# My Submission to Northern Beaches Council

Attention: Thomas Burns Planner Re: Mod2020/0715 - DA2018/0612  
7 Pavilion Street, Queenscliff

Mod 2020/0715 Nolan Planning

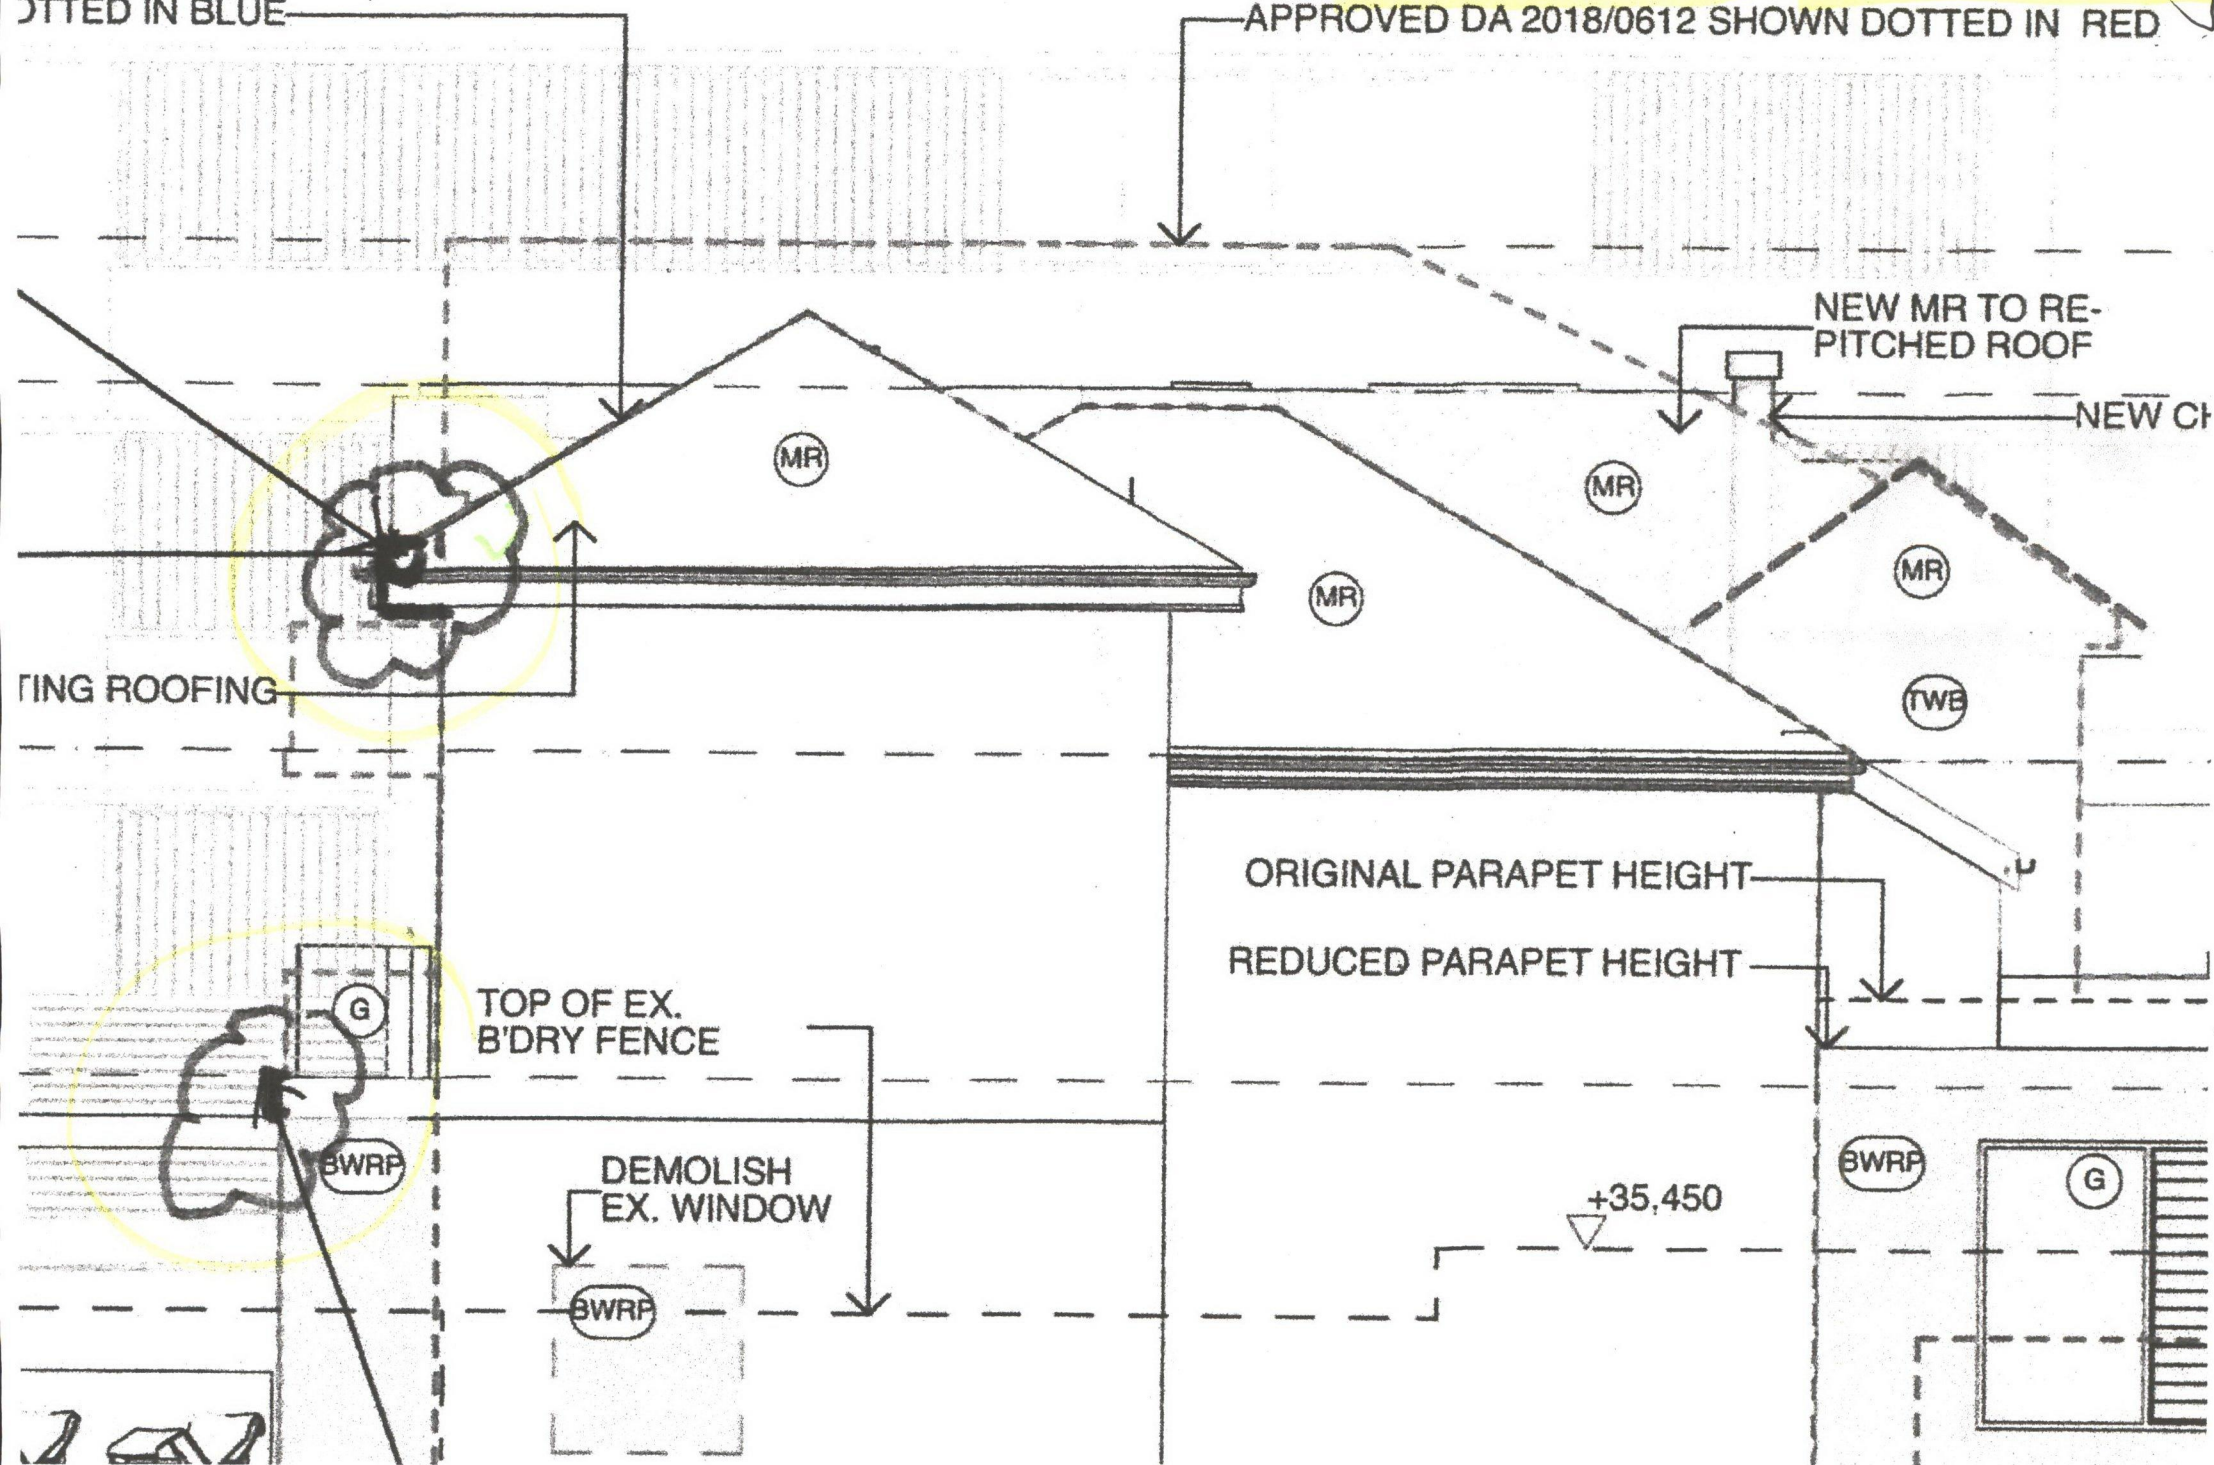
With regard to the Nolan Planning diagram in this MOD2020/0715, the 2 highlighted areas are not correctly drawn, as the roof and gutter were built (IMG 5110), and later a new scaffold was constructed to add the box like ceiling structure that now exists built out to the East from that gutter, IMG 5264 taken 18/5/20.

I would like the box like structure added to the N/E gutter to be removed as it was never in the approvals. It is drawn inaccurately in Nolan Planning's diagram in this Mod, when in fact the box is built out 400mm approx. to the east from the gutter. This box sits in our view from our bedroom. I request that the Pagola/Operable Roof be set back 1 metre from the current temporary position of the 2 posts (and temporary roof) and be rebuilt as scaled in the approved drawings. I question the cliff setback compliance of this structure?

7 Pavilion St, Courtyard IMG-1608 1 February 2019

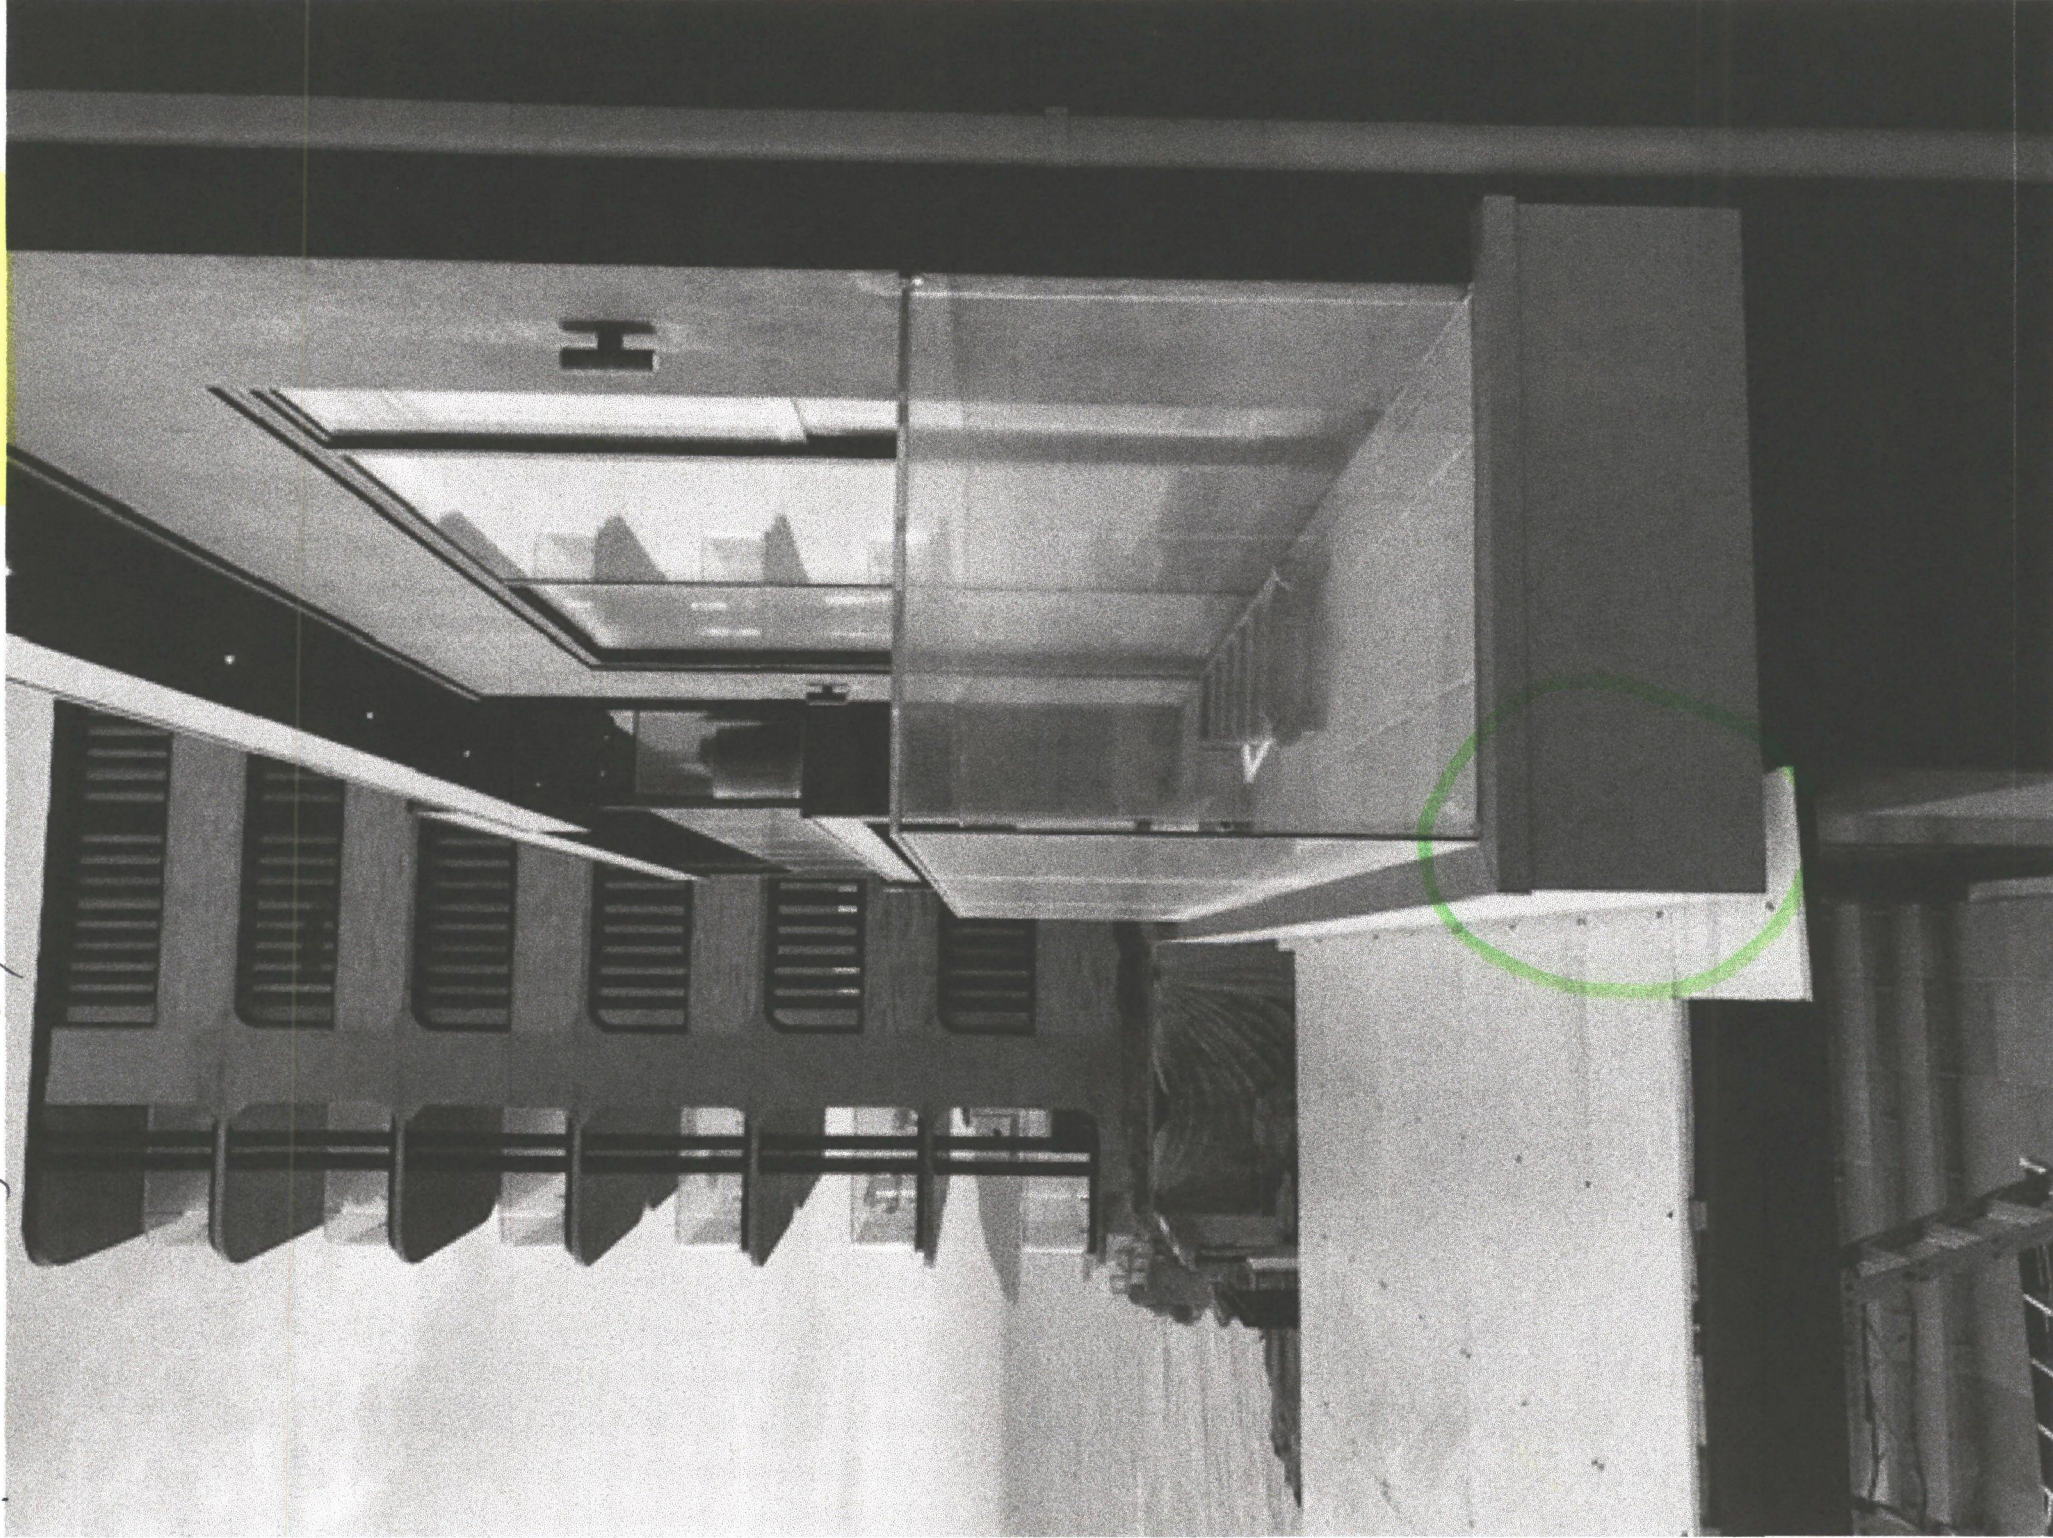
All the structures on the north/eastern seaside courtyard ~~back~~ areas of 7, against and near our joint boundary, were removed and rebuilt at least one metre closer to the cliff edge as you can see from IMG 5496 dated 22/1/21 compared to IMG 1608 of the original courtyard, dated 1/2/19. This is not as per the approved drawings, which matters I have discussed with your Compliance Officer, Blake Cousemaker, who visited our home on Tuesday 2nd February and who has copies of all the photos which detail this cliff edge area prior to DA and Mods and after construction i.e. what exists today. The newly built structures are all at least one metre closer to the cliff than actually approved on the DA and Mod plans as above.

1146-5496 taken 20/6/20

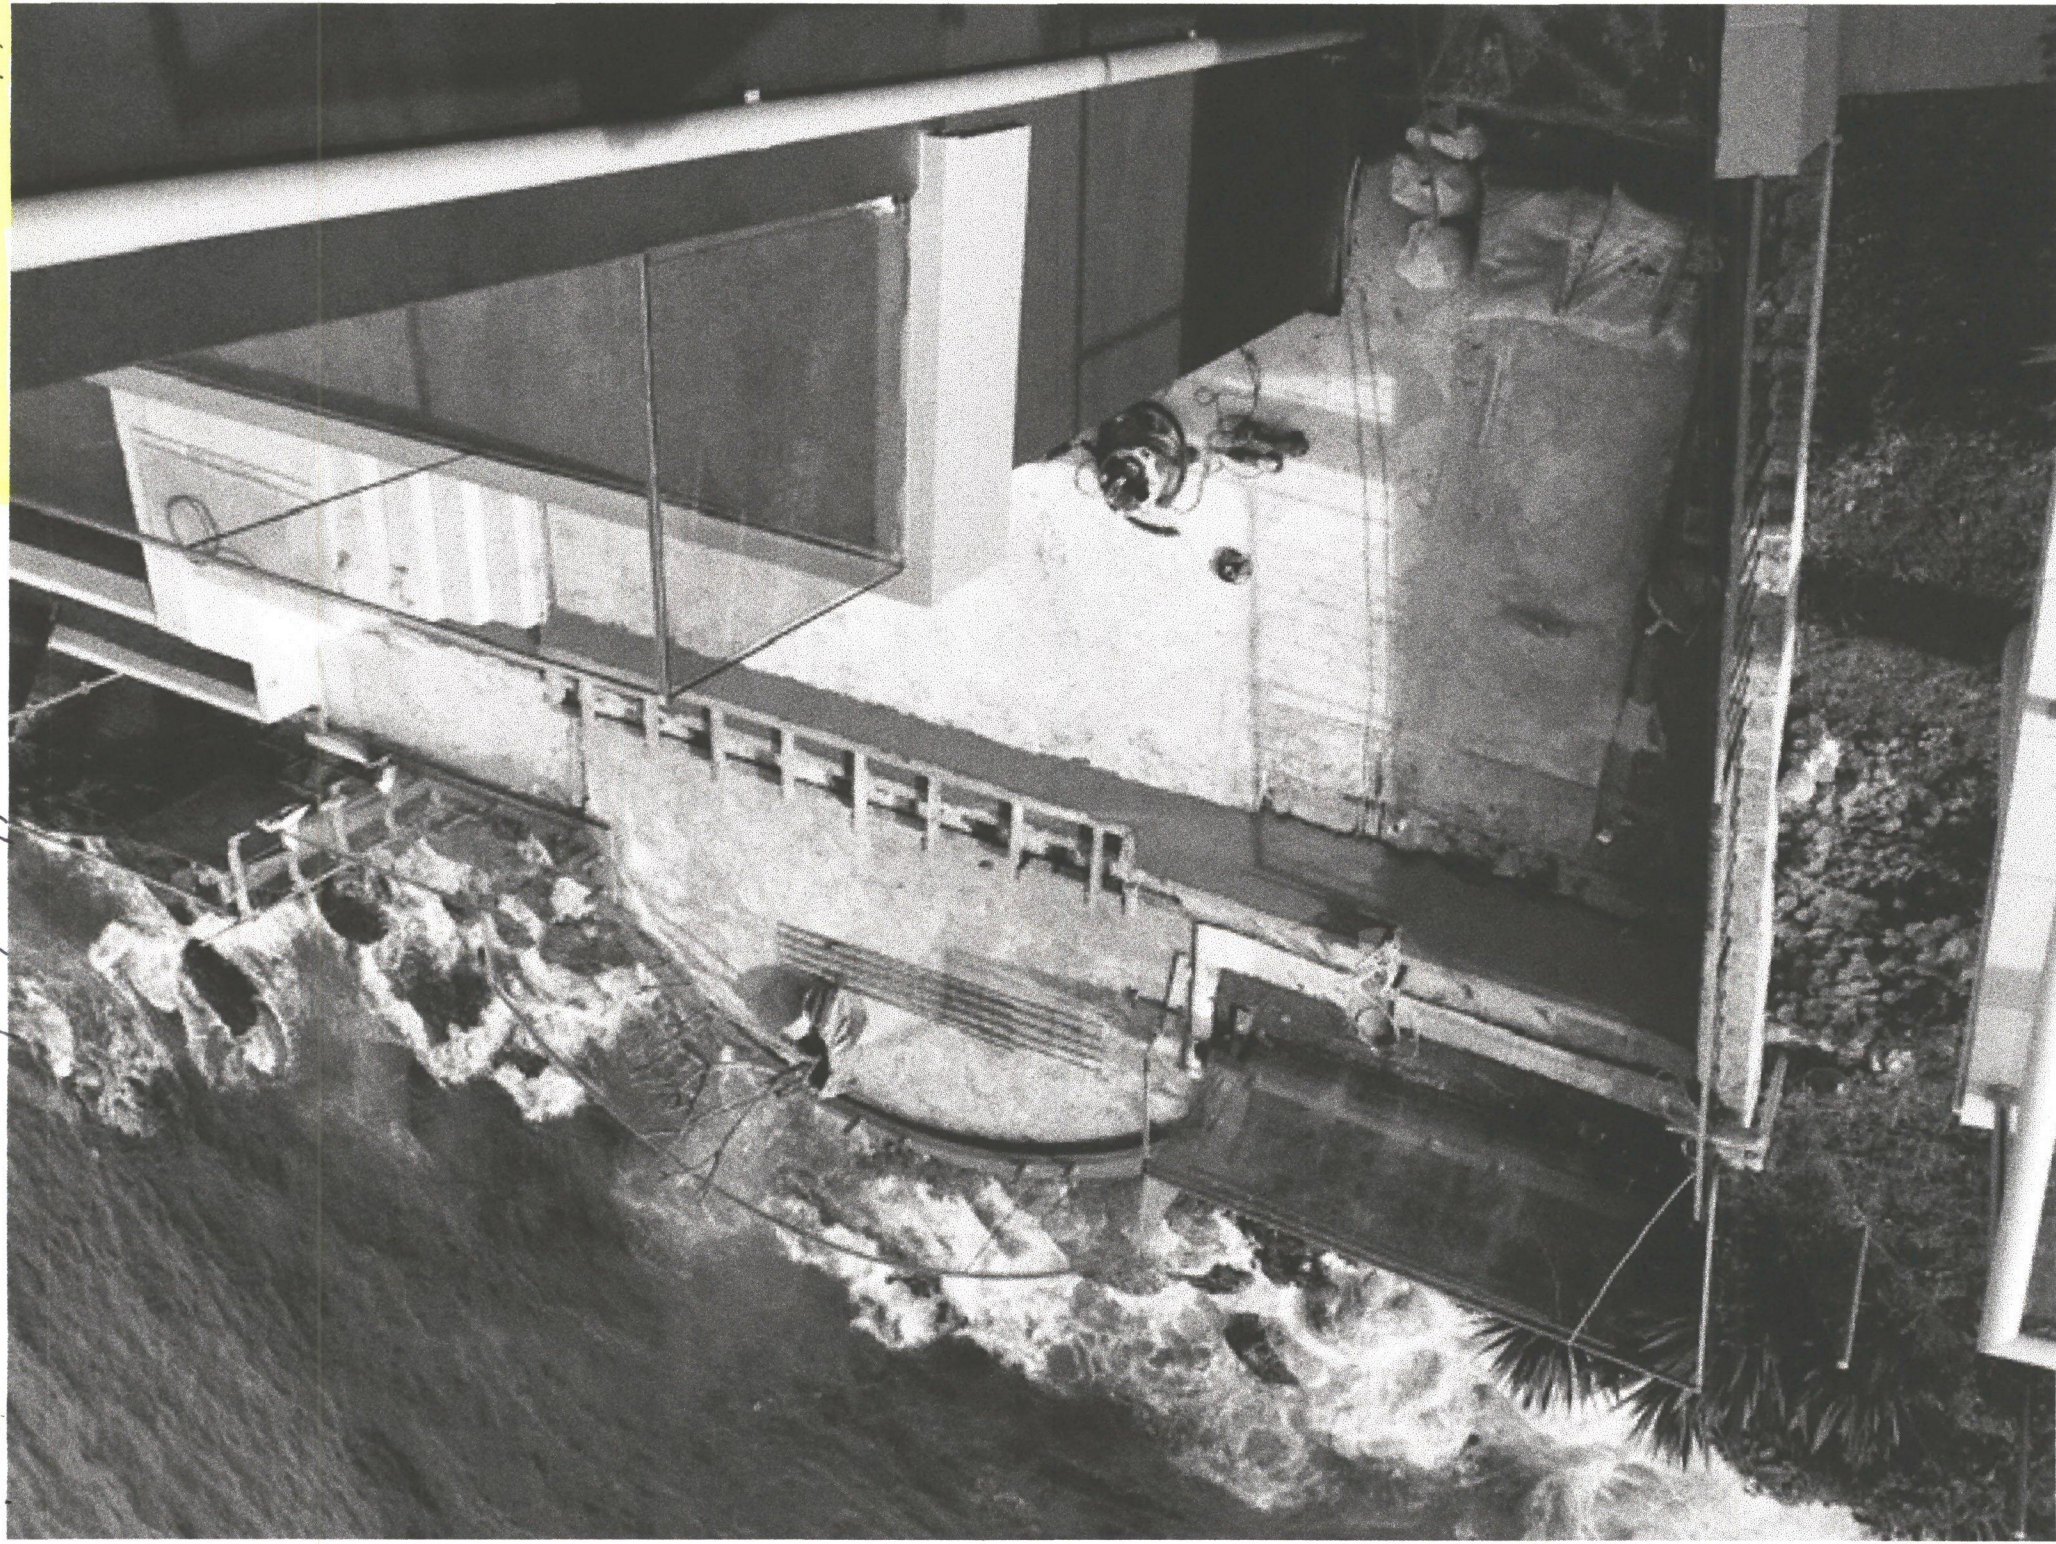
IMG 5496 & 6529 show the rebuilding of the steps down to the circular balcony area which have moved closer to the cliff edge and the construction of the new outdoor kitchen larger and closer to the cliff edge. The positioning of the pagola posts closer to the cliff and taller than originally, which sit directly in our living room views. The approved plans state "replace existing pergola" and MOD 0173 calls it an 'operable roof'. This pagola is not built to scale as per the approval.
